**STAFF RECOMMENDATION**  
**722 McFerrin Avenue**  
**April 22, 2020**

**Application:** New Construction - Infill  
**District:** Maxwell Heights Neighborhood Conservation Zoning Overlay  
**Council District:** 05  
**Base Zoning:** MUN-A  
**Map and Parcel Number:** 082080286  
**Applicant:** Brandon Williams  
**Project Lead:** Jenny Warren, jenny.warren@nashville.gov

<p><b>Description of Project:</b> Application for new construction of a mixed use building.</p> <p><b>Recommendation Summary:</b> Staff recommends denial of the application, finding that the project does not meet the following design guidelines:</p> <ul style="list-style-type: none"> <li>• Sections II.B.1.a.and b for height and scale</li> <li>• Section II.B.1.c for setback and rhythm of spacing</li> <li>• Section II.B.1.e for roof form</li> <li>• Section II.B.1.f for orientation</li> <li>• Section II.B.1.g for proportion and rhythm of openings.</li> </ul>	<p><b>Attachments</b> <b>A:</b> Photographs <b>B:</b> Site Plan <b>C:</b> Elevations</p>
---	--

**MIXED-USE RESIDENTIAL: 722 McFERRIN LOFTS**

Figure 4: Footprint map showing setbacks from McFerrin. White box indicates approximate appropriate front setback for 722 McFerrin

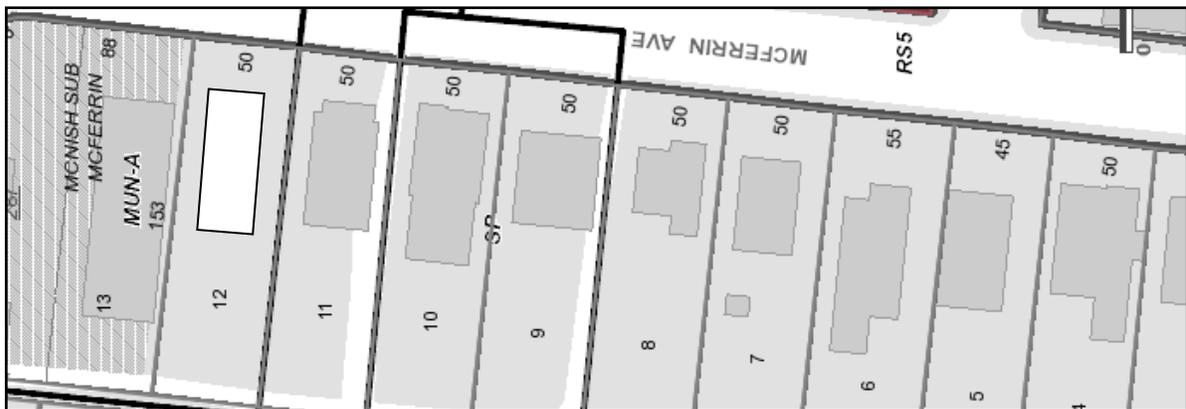
The proposed front setback is one foot, six inches (1'6"). All of the historic houses to the left of the subject lot have consistent setbacks. The infill should match the setbacks of these historic houses, rather than sit on the sidewalk.

An exterior stair encroaches on the five foot (5') right side setback, which staff finds to be inappropriate. The setback on the left side is just under twelve feet (12'), allowing room for the driveway on this side. This configuration is appropriate to the context of this block.

Staff finds that the project does not meet section II.B.1.c for the front setback.

**SITE LAYOUT**

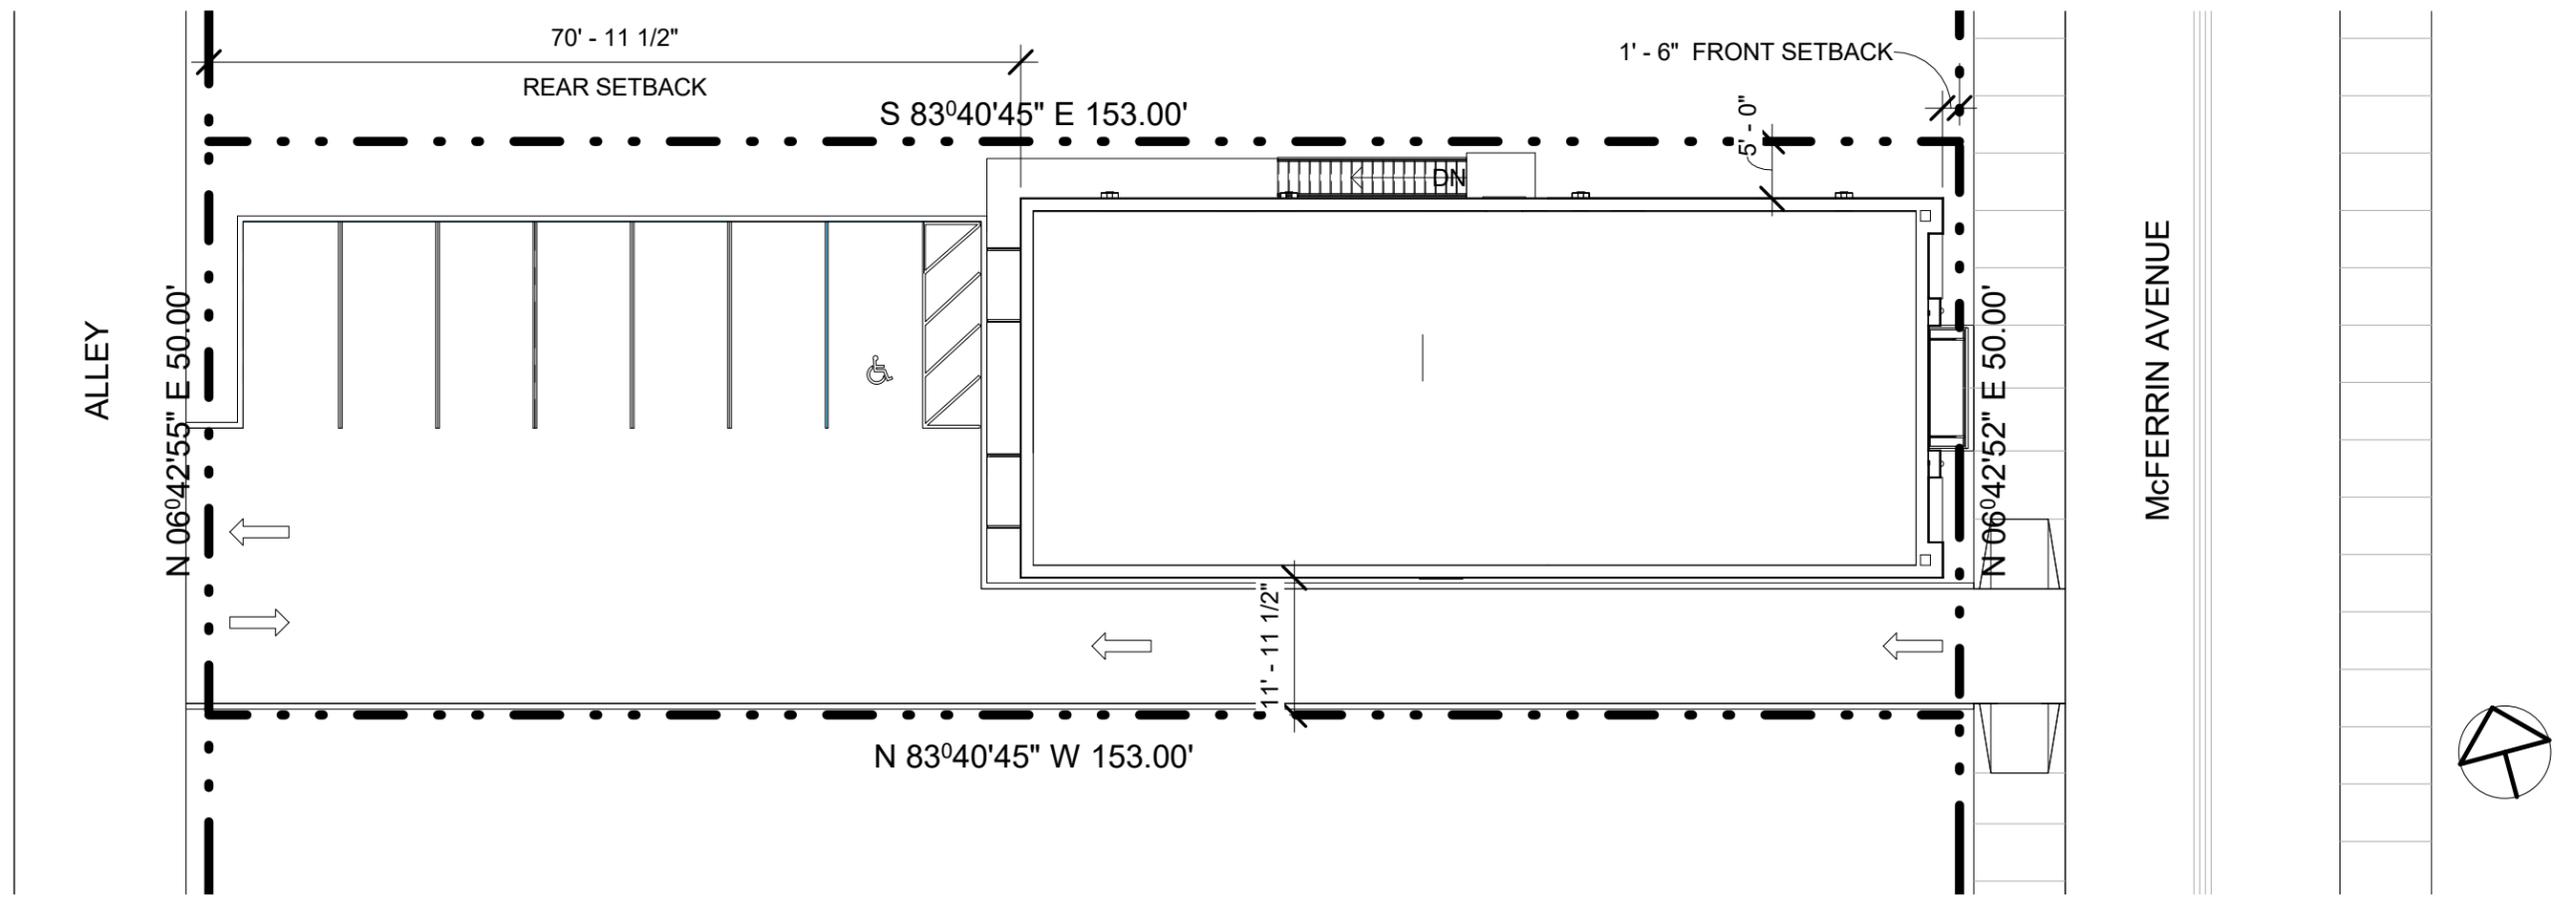
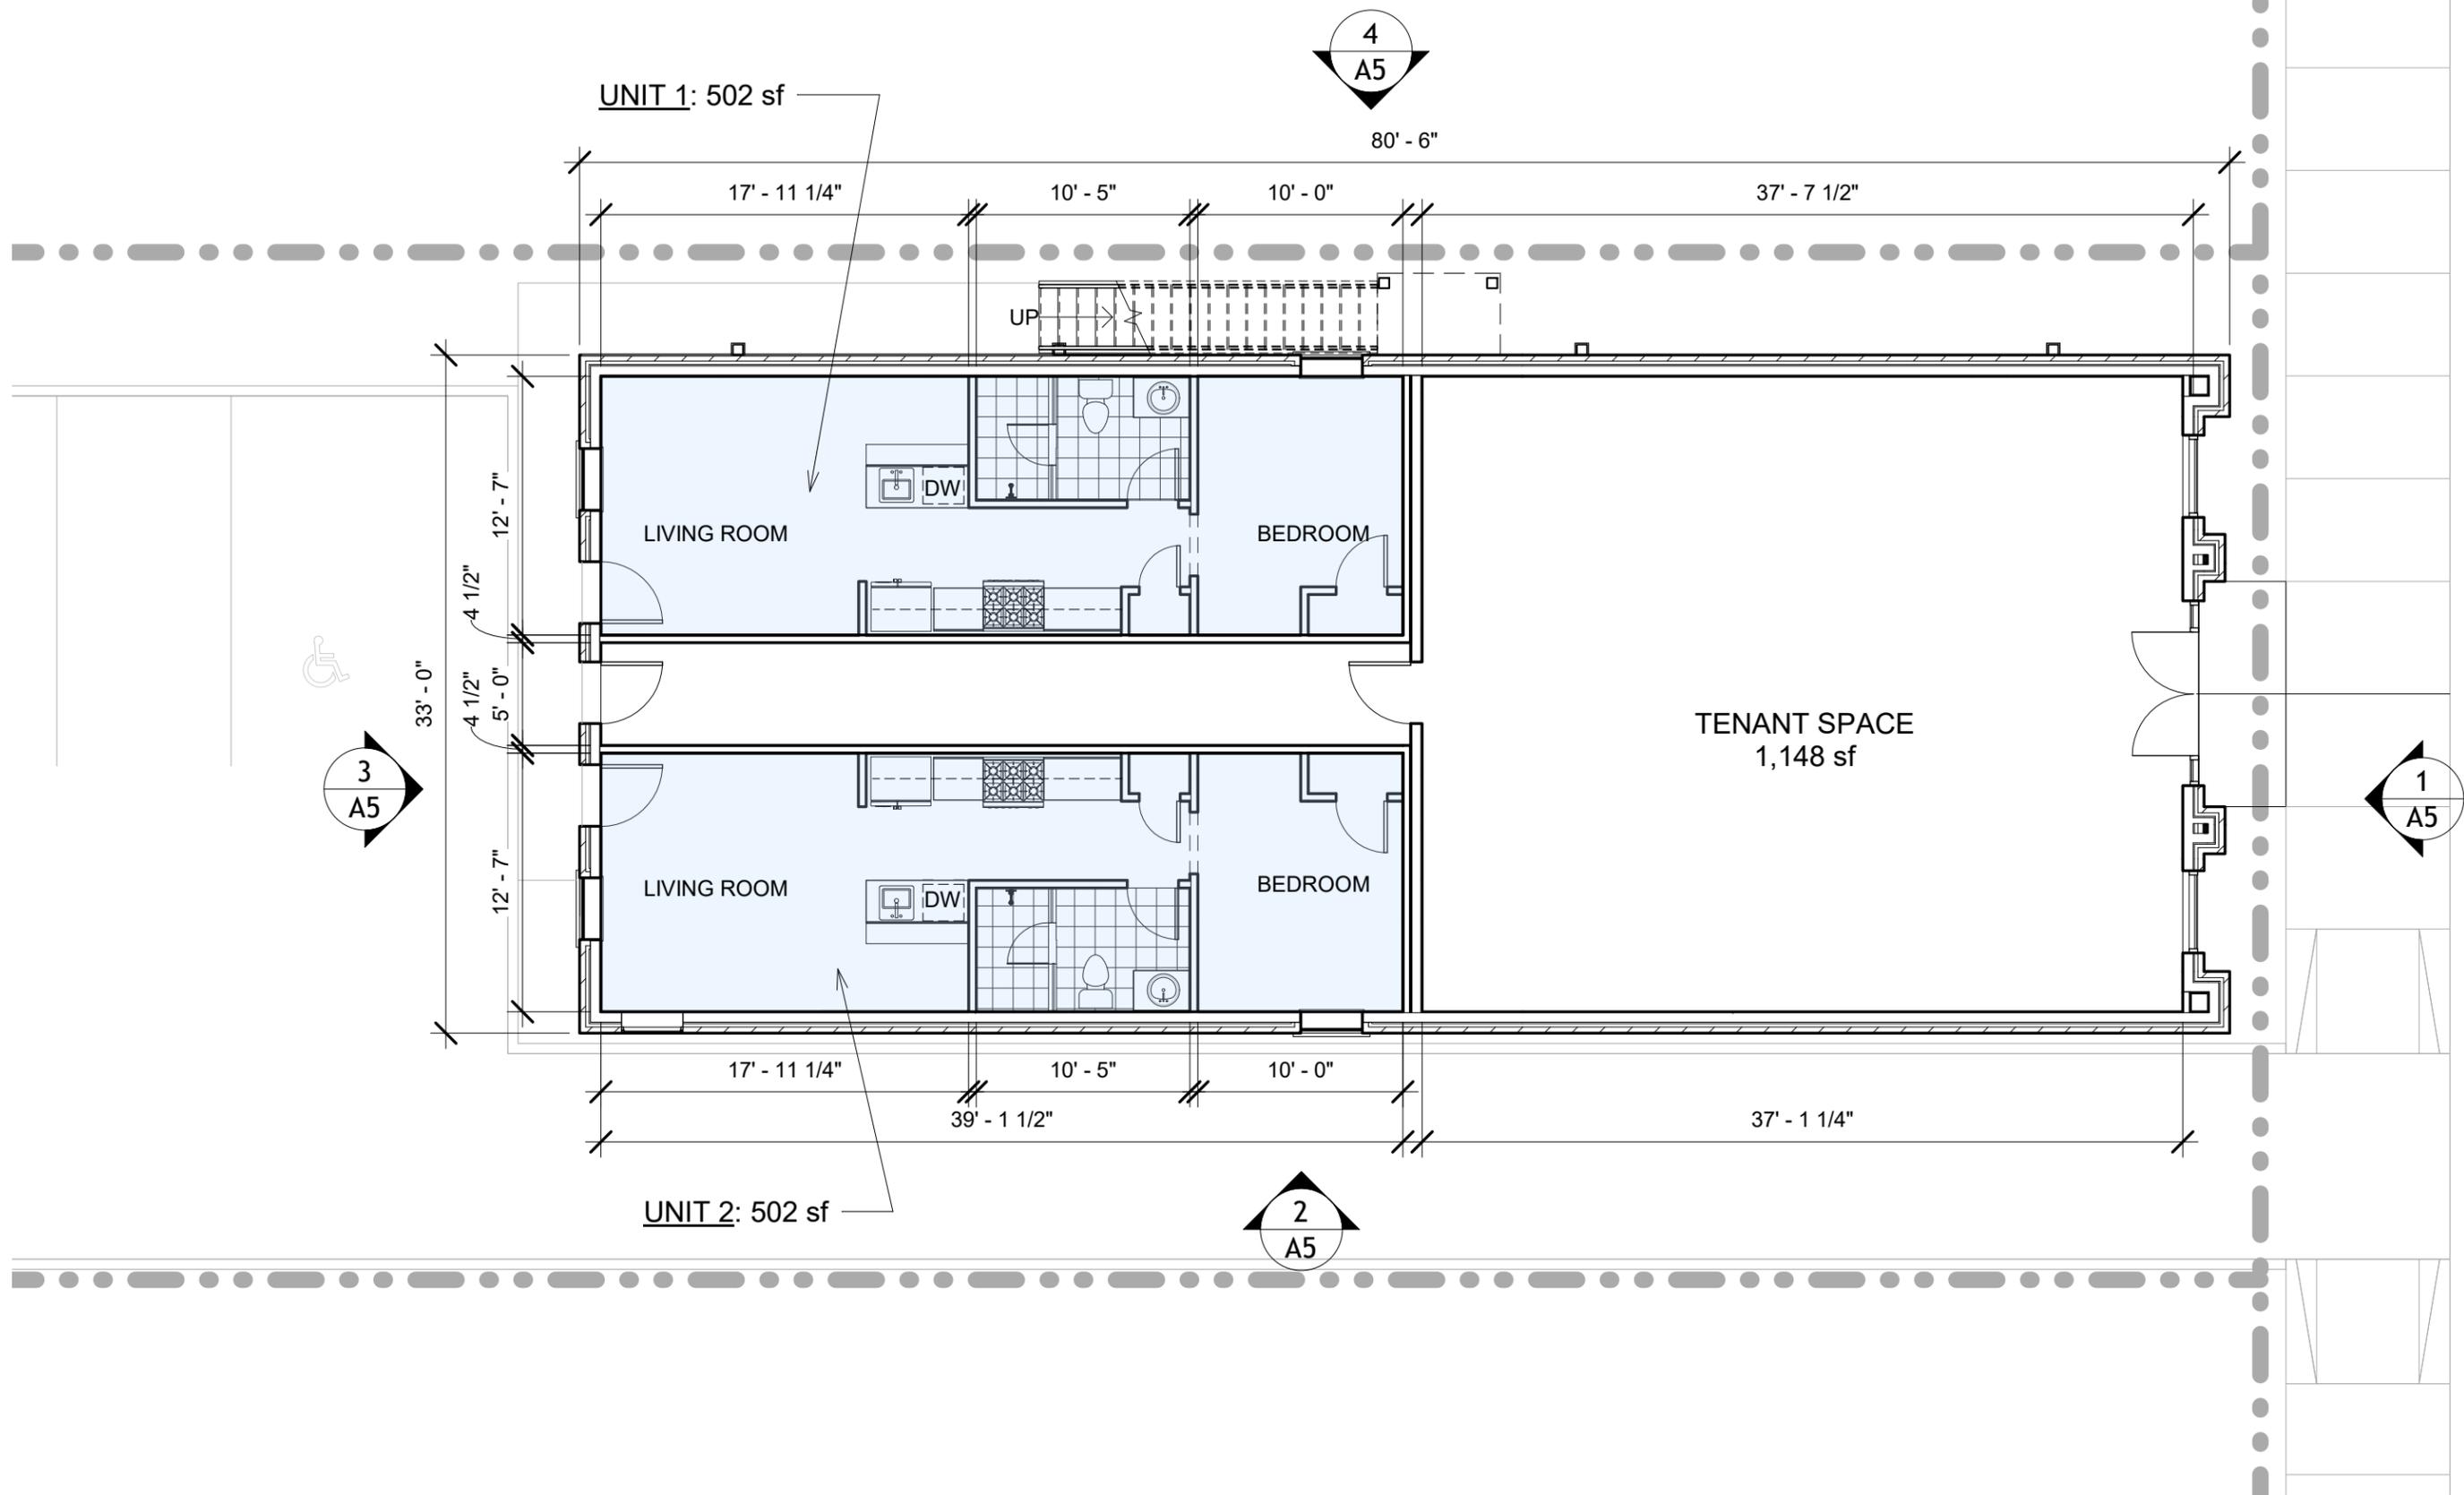
The building is oriented to McFerrin Avenue, which is appropriate. Due to the shallow setback and commercial form, there is no front walkway or porch. There is an awning that covers the central entry doors. The historic context consists of houses with front walks, porches, and significant setbacks, the infill should also have these elements in order to meet the design guidelines.

The site plan includes a driveway accessed from McFerrin Avenue, along the left side of the property. This is a common condition on this block and staff finds that maintaining a driveway from McFerrin Avenue is appropriate.

Staff finds that the proposal does not meet section II.B.1.f for orientation due to the front setback, the lack of a porch and the lack of a walkway.

**EXTERIOR  
ELEVATIONS**

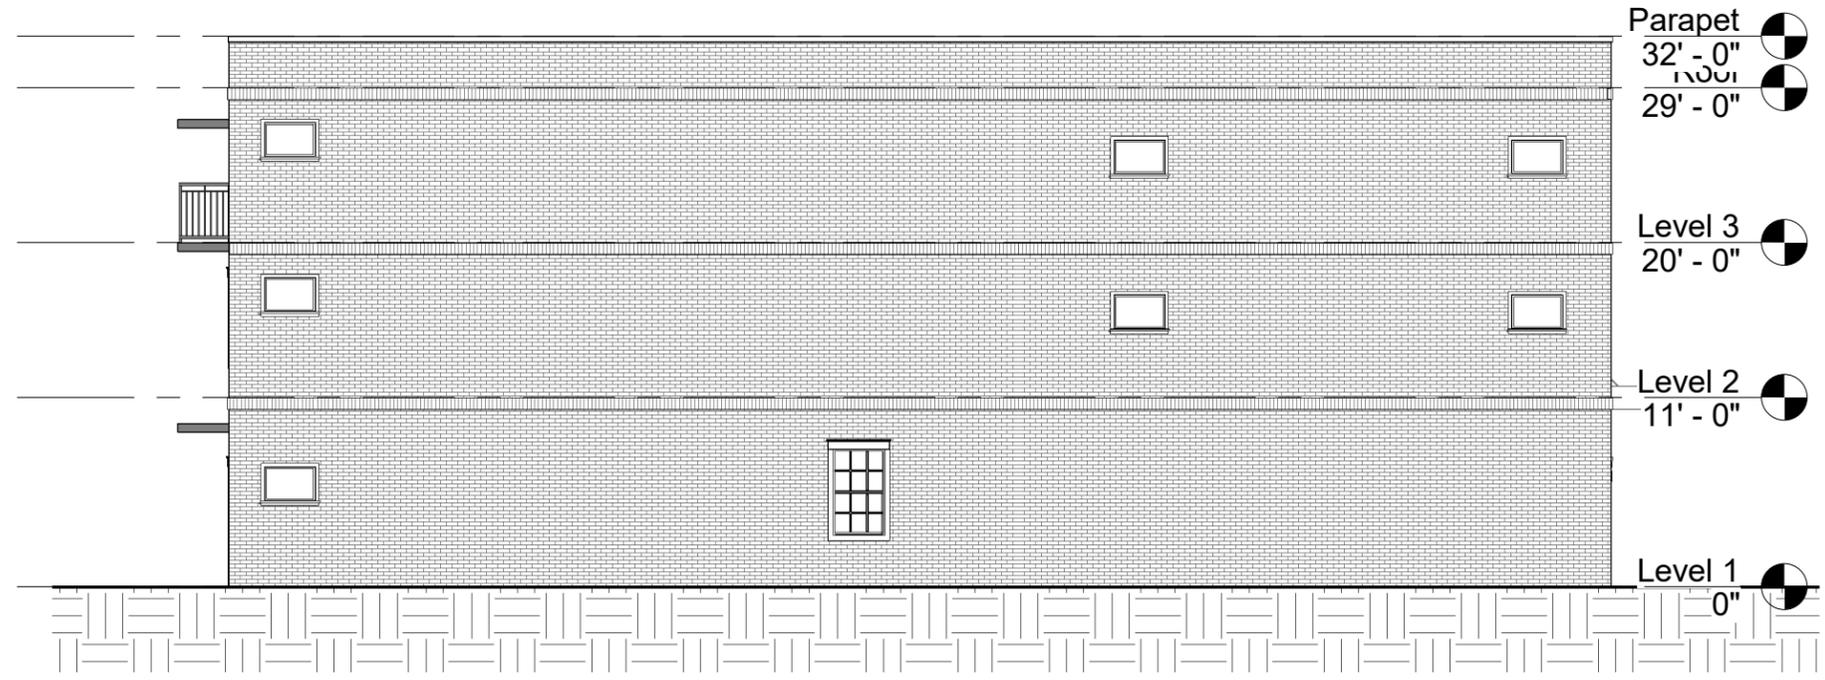
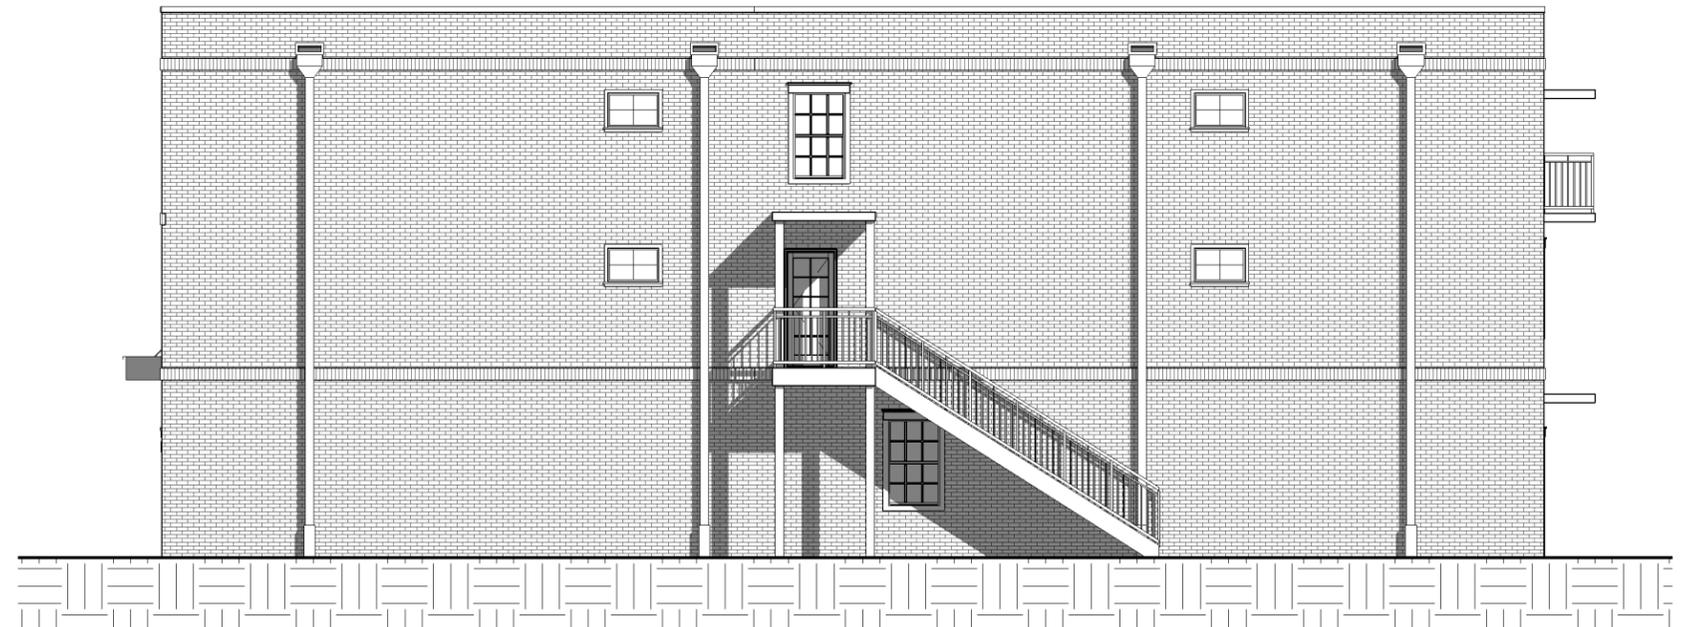
The new construction is proposed to be thirty-two feet (32') tall. The historic context includes houses that are between about fifteen and twenty-seven feet (15'-27') tall. Additionally, the historic houses all have a pitched roof, so their heights reflect the peak of the ridge – in other words, only a small portion of the massing of the historic houses are actually this tall. The new construction has a flat roof

form, so the entire building would be a full thirty-two feet (32') high and would sit next to a historic house with a height of about twenty-one feet (21') to the peak of its hipped roof. (Figure 3)

Staff finds that the height is not appropriate for the historic context and should not be taller than about twenty-one to twenty-seven feet (21'-27') – though a smaller structure could also be appropriate.

The building is proposed to be thirty-three feet (33') wide and the lot is fifty feet (50') wide. The historic houses on this block all have similarly sized lots and range in width from about twenty-six to thirty-six feet (26'-36') wide. Staff finds that the proposed width is appropriate for the historic context.

Staff finds that the proposed infill does not meet sections II.B.1.a. and b for height and scale.

The proposed roof is flat with a parapet. The guidelines state that roofs should have a similar pitch to those found in the district, generally between 6/12 and 12/12. As explained above, under “Height and Scale”: the historic houses all have a pitched roof, so their heights reflect the peak of the ridge – in other words, only a small portion of the massing of the historic houses are actually this tall. The new construction has a flat roof form, so the entire building would be a full thirty-two feet (32’) high and would sit next to a historic house with a height of about twenty-one feet (21’) to the peak of its hipped roof. Additionally, the flat-roofed form uses no eaves to help mitigate the height of the structure.

The project does not meet section II.B.1.e for roof form.

On the front and rear elevations the window and door openings are twice as tall as they are wide, thereby meeting the historic proportion of openings. On the side elevations, there are very few windows and those that do exist are primarily small horizontal windows. If the form were appropriate, staff would recommend that there be a window every eight to thirteen feet (8'-13') in accordance with the guidelines. The majority of these windows should be twice as tall as they are wide. With the addition of windows to the side elevations, staff finds that the project's proportion and rhythm of openings could meet Section II.B.1.g.

The proposal includes an exterior staircase on the side elevation, which the Commission has not approved in the past. Exterior stairs are not a historically appropriate features and are typically only approved on rear elevations. The location of the HVAC and other utilities was also not noted. If the form were appropriate, Staff would recommend that the HVAC be located on the rear façade, or on a side façade beyond the midpoint of the infill. The project meets section II.B.1.h.
